# STANTON WILLIAMS

**Introduction**

In January 2009, Argent and Stanton Williams presented to the London Borough of Camden and English Heritage a proposal to modify the approved design of the Northern Elevation of the Eastern Transit Shed.

PYRAMID BUILDERS LTD SURVEY 02  
PROPOSED FACADE REPAIR (WITHIN CENTRAL ARCH)

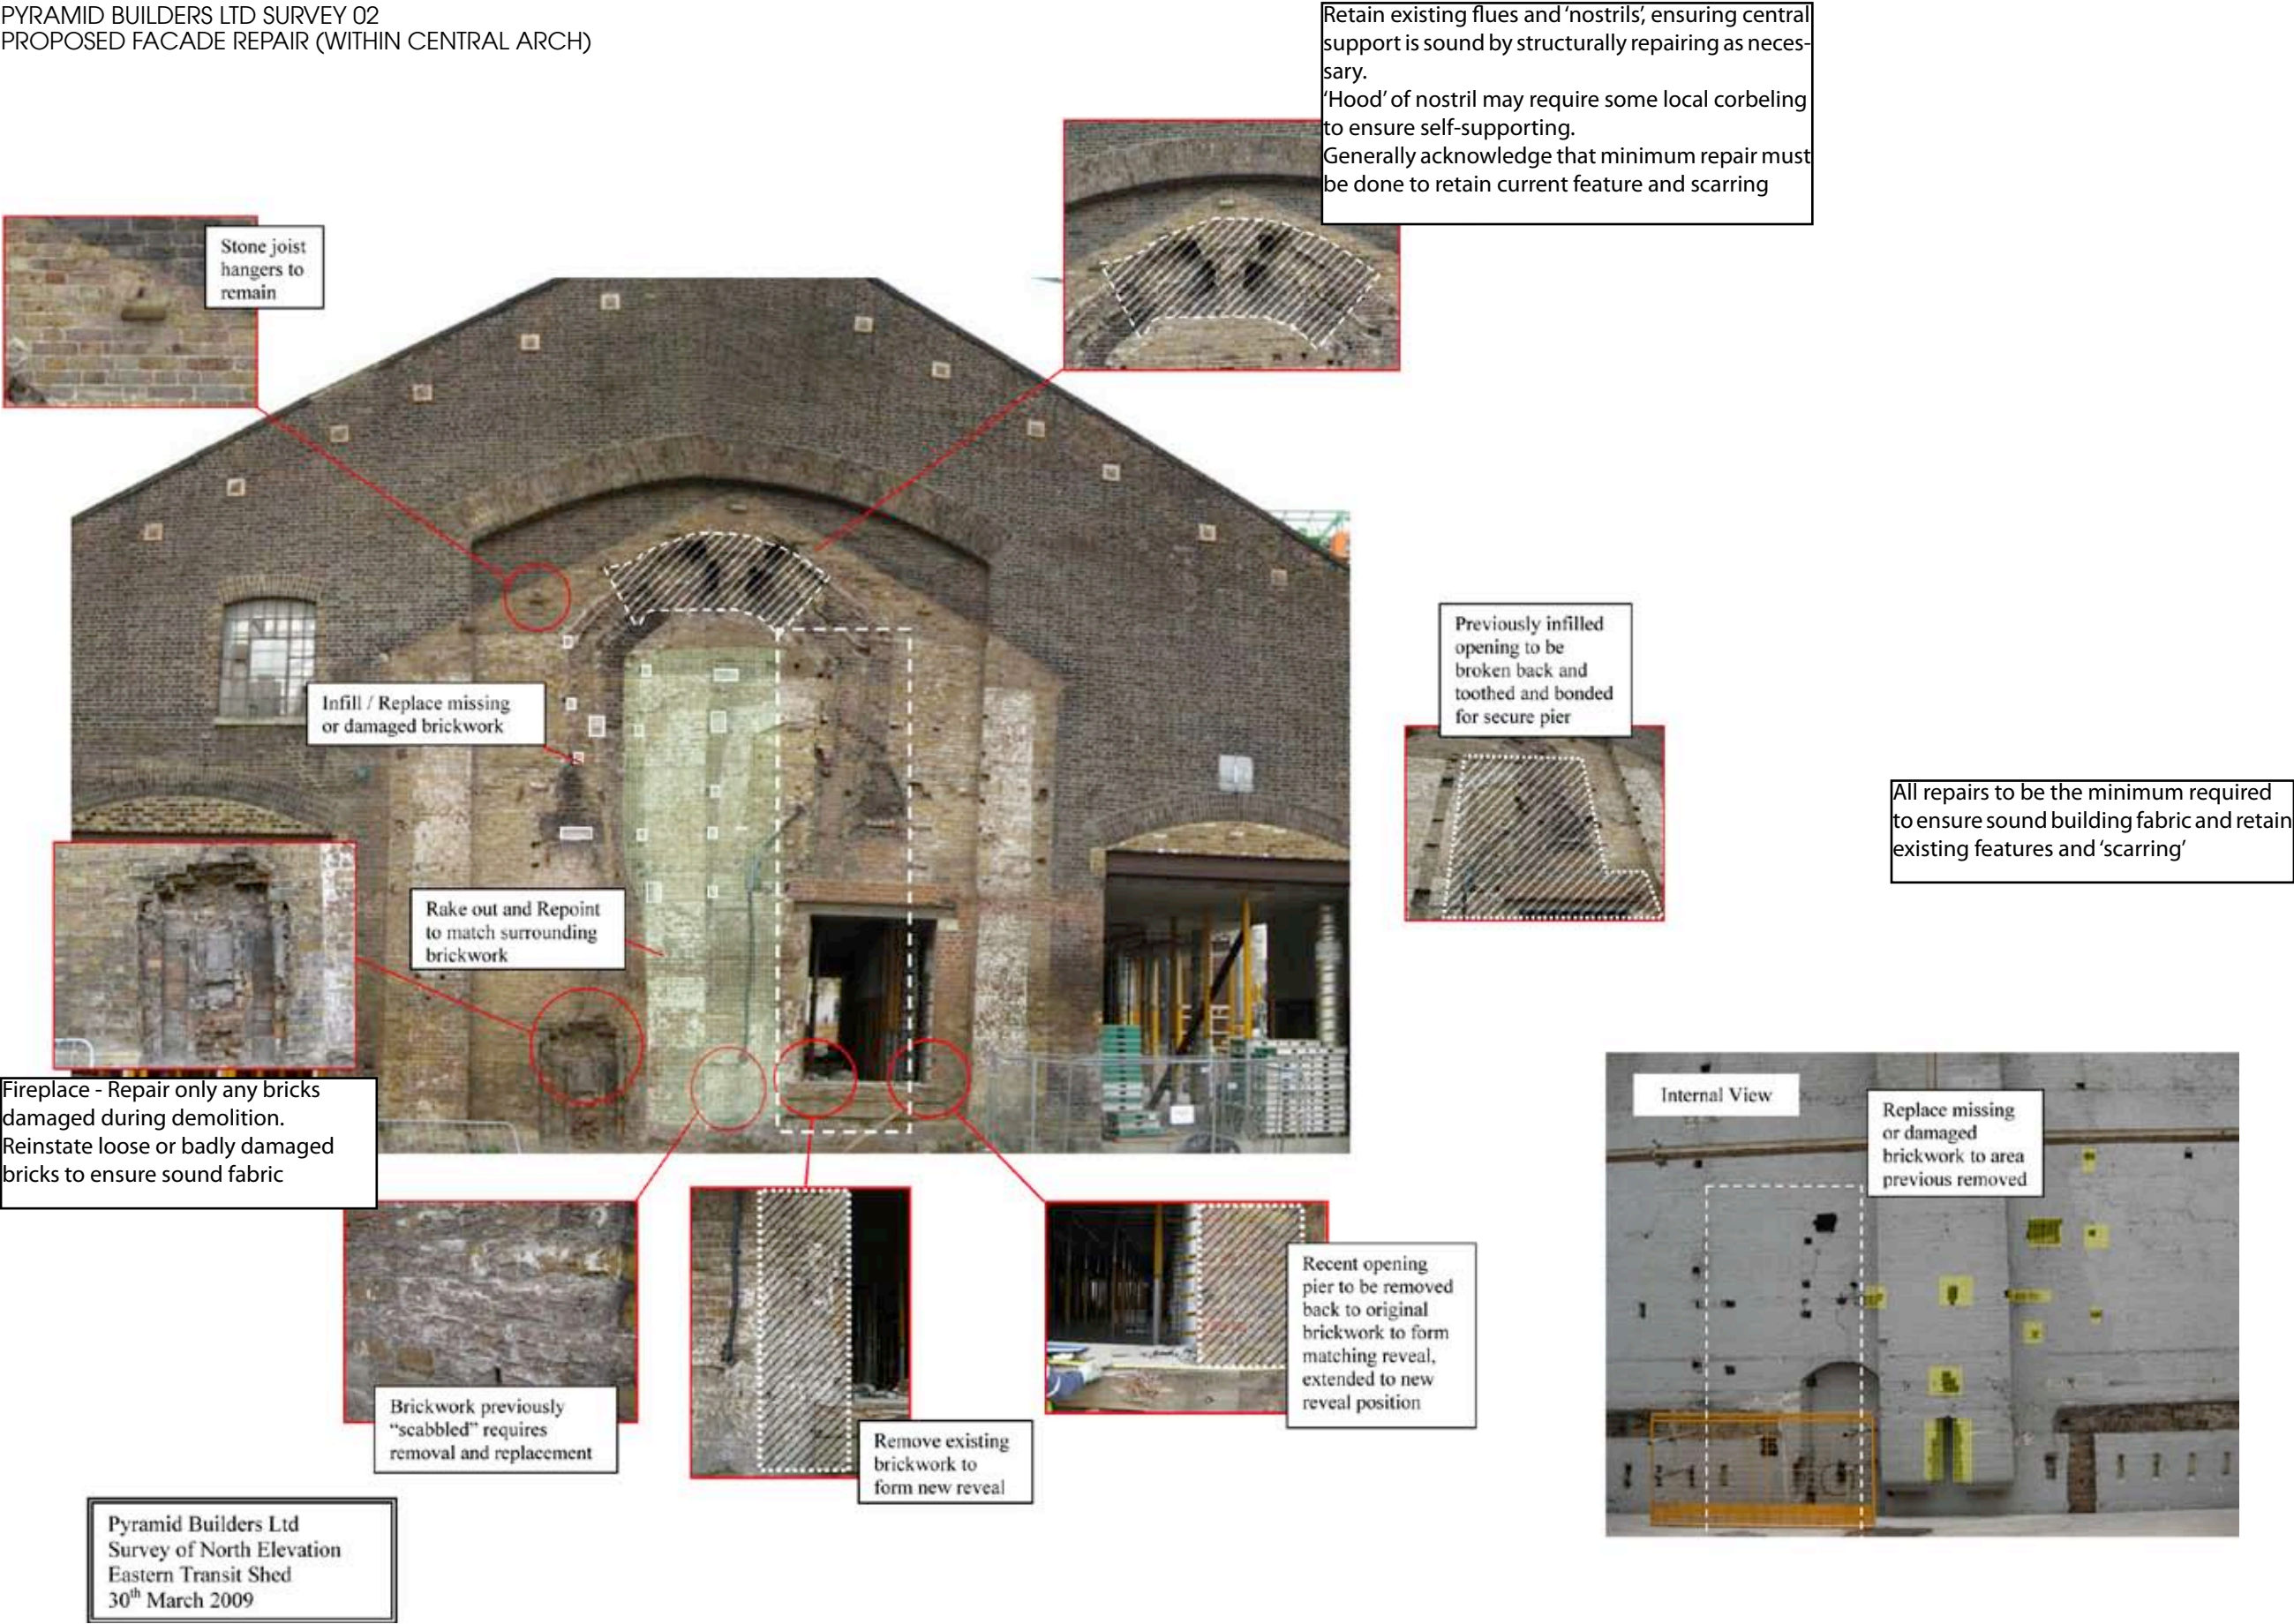
Appendix D includes drawings which detail the proposed areas of repointing and repair work to be completed on the northern façade of the Eastern Transit Shed. Survey 1 with associated schedule by Richard Griffiths Architects shows the repair work proposed outside of the existing central blind arch. Works to the area within the central arch, which includes the brickwork previously to be removed under the original Reserved Matters approval and Listed Building Consent, is shown in a separate drawing (Survey 2) by Pyramid Builders Ltd. Principally the works will involve repairs to and repointing of existing brick features and ‘scars’ on the façade to ensure that the façade is safe and structurally sound.
